SERVICE INFORMATION NO. SI-42NG-009

GARMIN Service Bulletin No. 0823 Revision C
ATA-Code: 34-00

**** MANDATORY ****
SERVICE BULLETIN
NO.: 0823 Rev C

SUBJECT: GDU 104X CRS/BARO Knob Interference

Figure 1

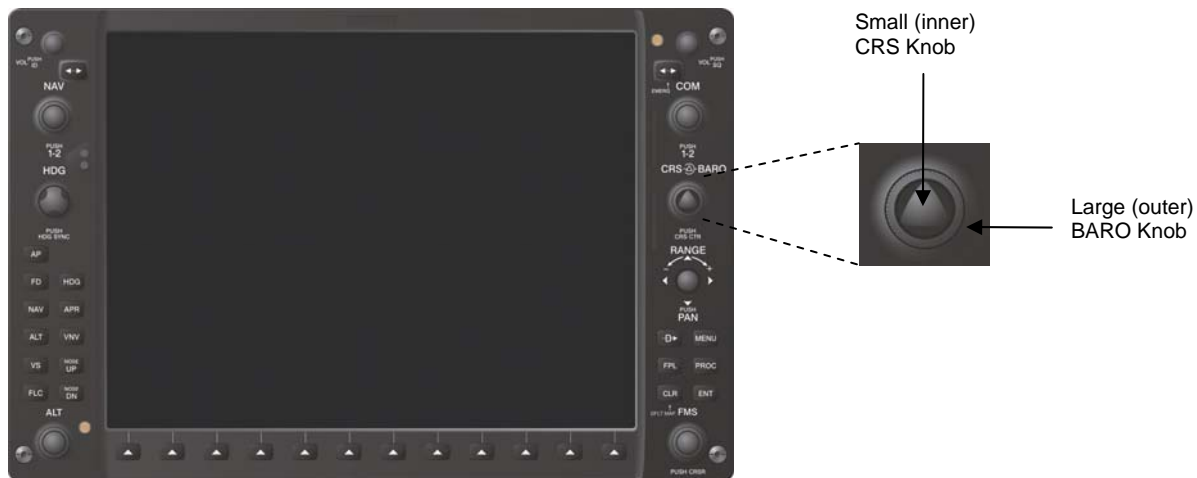
Garmin has identified an issue, whereby the large (outer) BARO knob and the small (inner) CRS knob may interfere with each other.

1. Apply power to the G1000/G900X/G950.
2. Press the CDI softkey on the Primary Flight Display(s) (PFD) to enter VOR mode on the HSI.
3. Rotate the large (outer) BARO knob (refer to Figure 1) a minimum of three complete revolutions in each direction while monitoring the Horizontal Situation Indicator/Digital Course Indicator (refer to Figure 3) on the PFD. If a change in the Horizontal Situation Indicator/Digital Course Indicator is produced while turning the BARO knob proceed to the Modification Instructions.

4. Rotate the small (inner) CRS knob (refer to Figure 1) a minimum of three complete revolutions in each direction while monitoring the Barometric Altimeter Setting (refer to Figure 3) on the PFD. If a change in the Barometric Altimeter Setting is produced while turning the CRS knob proceed to the Modification Instructions.
5. Repeat Steps 3 and 4 for each affected GDU.

Figure 4

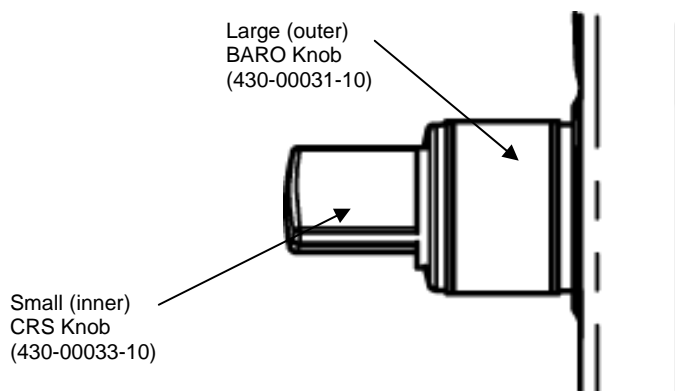
5. Grasp the large (outer) BARO knob (insuring proper orientation) and place it over the shaft.
6. Align the flat side of the knob insert with the flat side of the shaft.
7. Press down firmly to ensure knob is completely seated, refer to Figure 4.
8. Grasp the small (inner) CRS knob (insuring proper orientation) and place it over the shaft.
9. Align the flat side of the knob insert with the flat side of the shaft.
10. Press down firmly to ensure knob is completely seated, refer to Figure 4.
11. Perform the CRS/BARO Knob Interference Test (contained in the TESTING PROCEDURE section) again to confirm there is no interference.
12. Accomplish aircraft logbook entry to return aircraft to service in compliance with this service bulletin.
